STAFF RECCOMENDATION
Approval, with Conditions

CASE FILE NO.: Z0580-18-D

PROPOSAL: Design review of a 101 unit, five (5) story Home 2 Suites and associated site improvements including site access, circulation, landscape, and infrastructure.

Site Plan

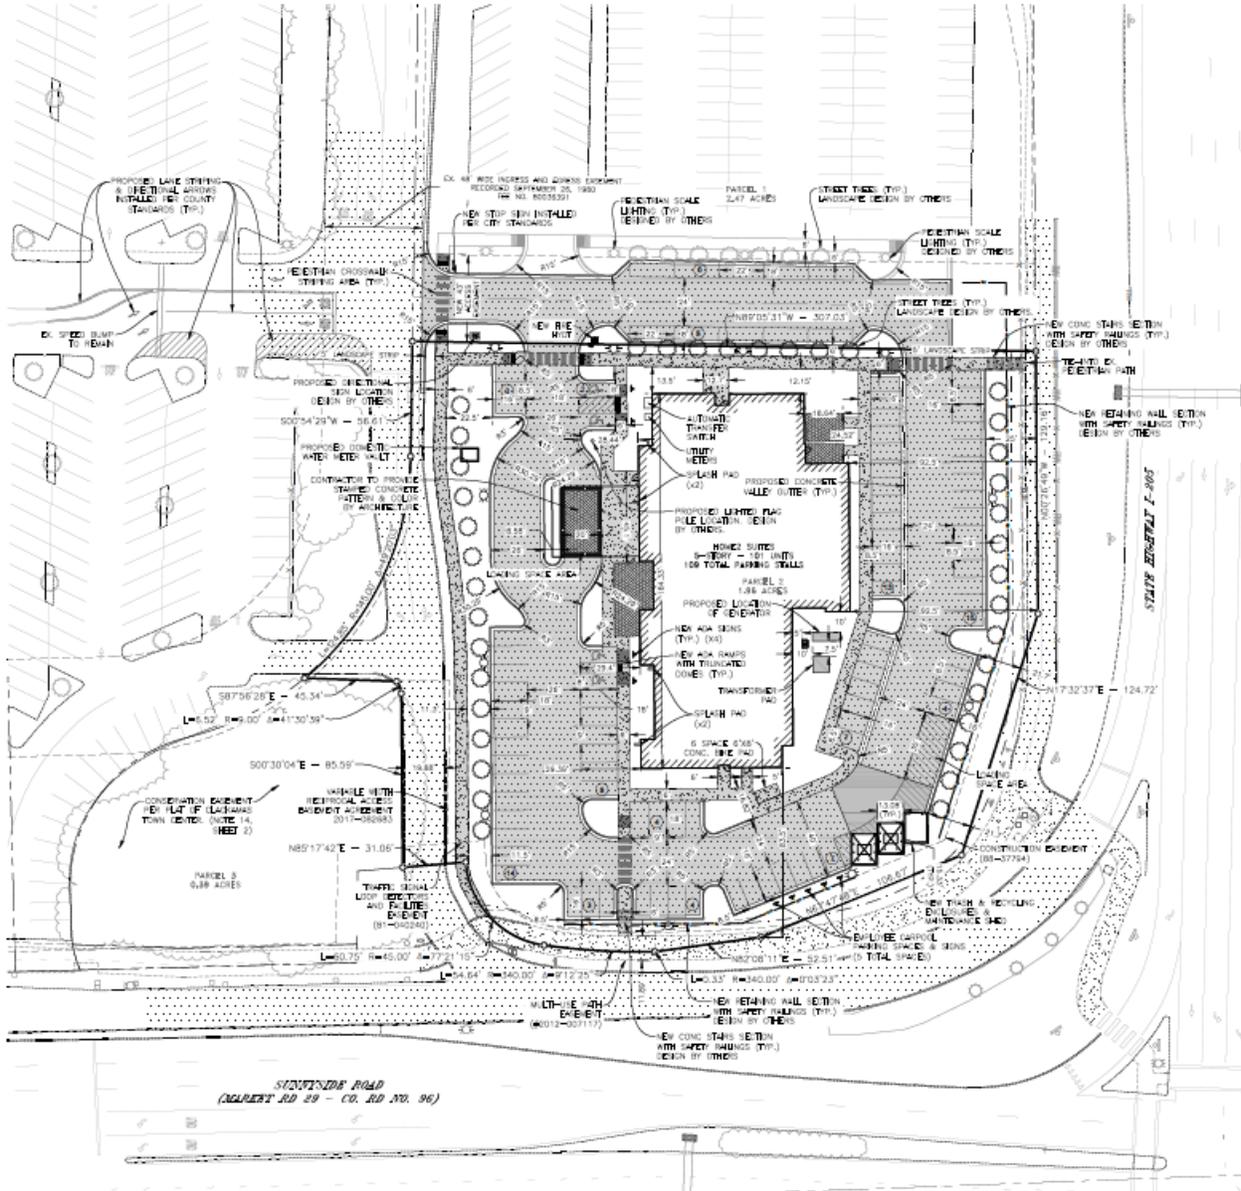
Finding: The site plan (Sheet C1) demonstrates clear compliance with these standards. The site has been laid out to satisfy the above criteria. Shared pedestrian walkways were added along the entire western and northern edges of the site to ensure full pedestrian connectivity is achieved throughout all portions of the property. Connections were also added at the southern portion and northeastern corner of the site to allow for pedestrian access to the current multi-use path running along the southern and eastern property lines. Site lighting has been designed to satisfy the above walkway lighting criteria. All walkways/sidewalk areas have been designed to be reinforced concrete pavement as advised. The Home2 Suites' public entrance is located greater than 75-feet from the westerly Clackamas Town Center Mall's drive/entrance off Sunnyside Road. The proposed walkway area west of the hotel's main entrance and adjacent to the mall's entrance has been designed to satisfy the above criteria. All parking spaces have been designed to abut typical 6-inch curbing sections throughout the site. The sidewalk areas abutting parking spaces are designed to be 6-ft wide in these areas. Furthermore, proposed walkways have been designed to satisfy the above interconnected walkway criteria. All walkway/sidewalk areas have been designed to ensure adequate grading and connectivity is achieved. These criteria are met.

Landscape Plan

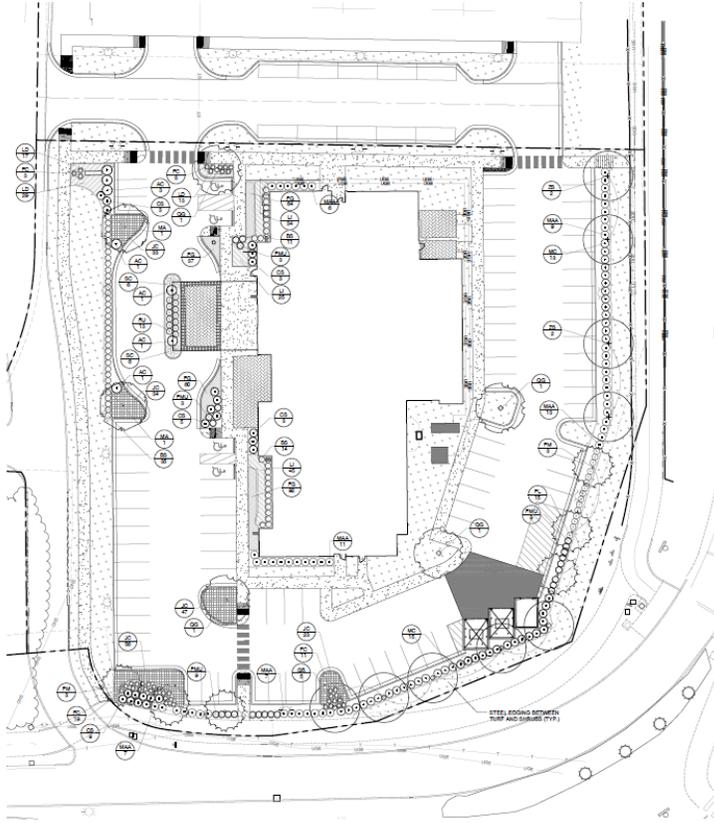
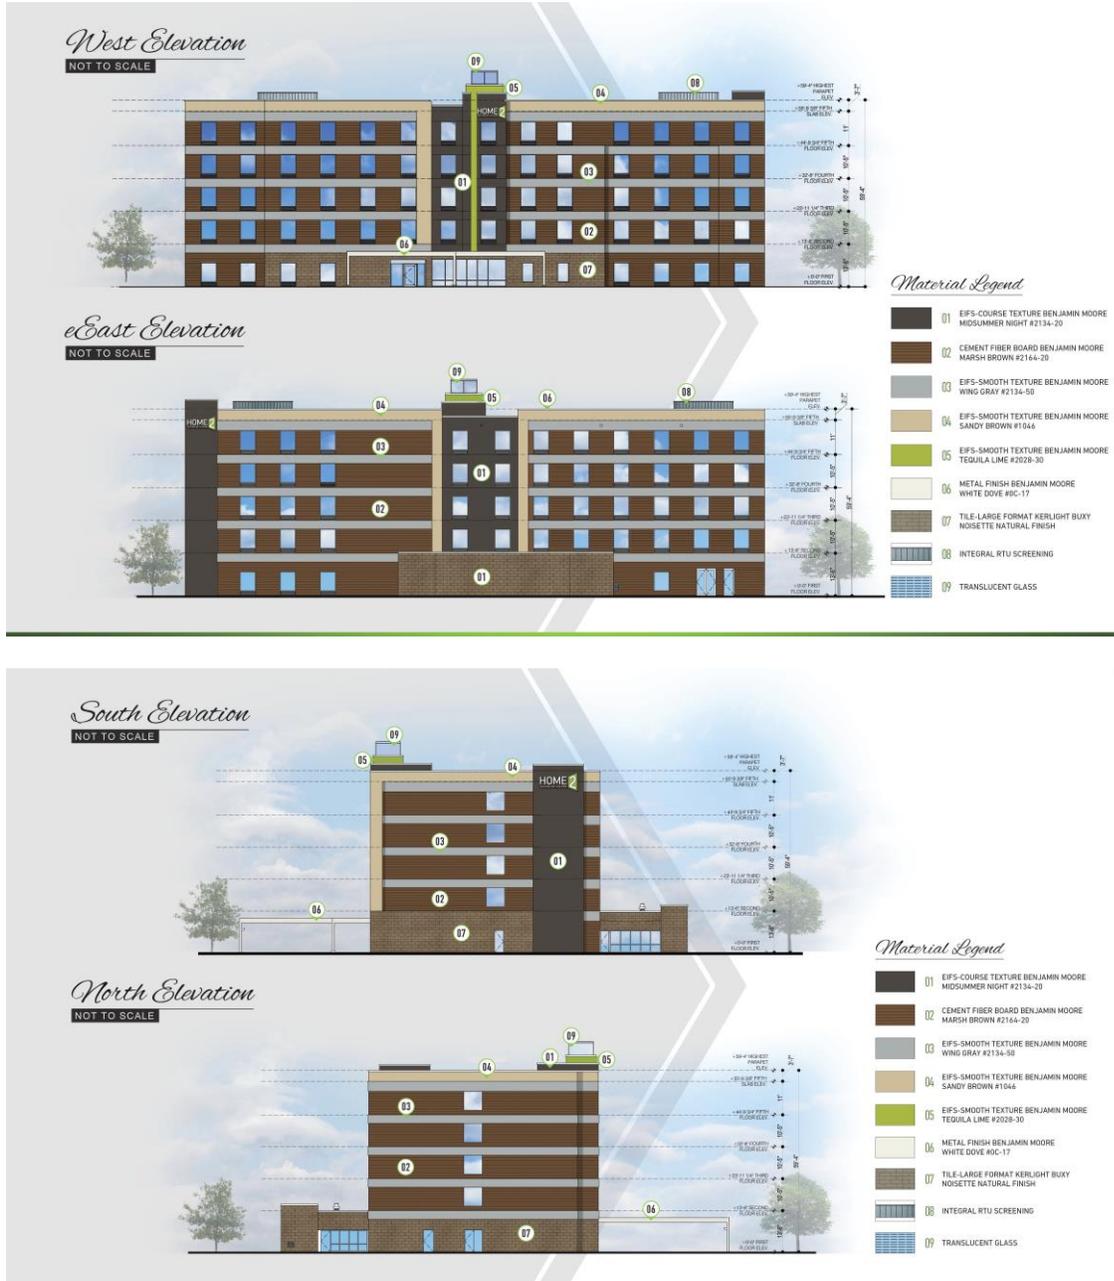
Finding: There is an area of buffering indicated on the landscape plan, as required per 1009.05(D), but there is not sufficient detail to determine compliance with 1009.05(E). **This does not comply with the standard. This standard can be met with a condition of approval.**

Finding: The submitted materials indicate that planting are to be maintained and replaced if not alive for two years. **The applicant has not submitted a separate written guarantee of the materials. This does not comply with the standard. This standard can be met with a condition of approval.**

Finding: It is not clear from the submitted landscape plan indicates that plantings shall be such that 90% groundcover will be achieved within three years of planting. This standard is met.

8. The applicant shall submit a signed maintenance contract, or provide a financial guarantee pursuant to Section 1311, Completion of Improvements, Sureties, and Maintenance, covering the landscape maintenance costs during the guarantee period.
9. The applicant shall submit detailed information regarding proposed signage, including dimensions and locations of all signs in order to comply with Section 1010 of the ZDO.
10. The applicant shall submit additional information and plans to detail the proposed landscape buffering, since there is not sufficient detail to determine compliance with 1009.05(E).
11. The applicant shall supply a signed Preliminary Statement of Feasibility from WES, indicating that suitable capacity for the proposed development exists, as required by ZDO 1008.
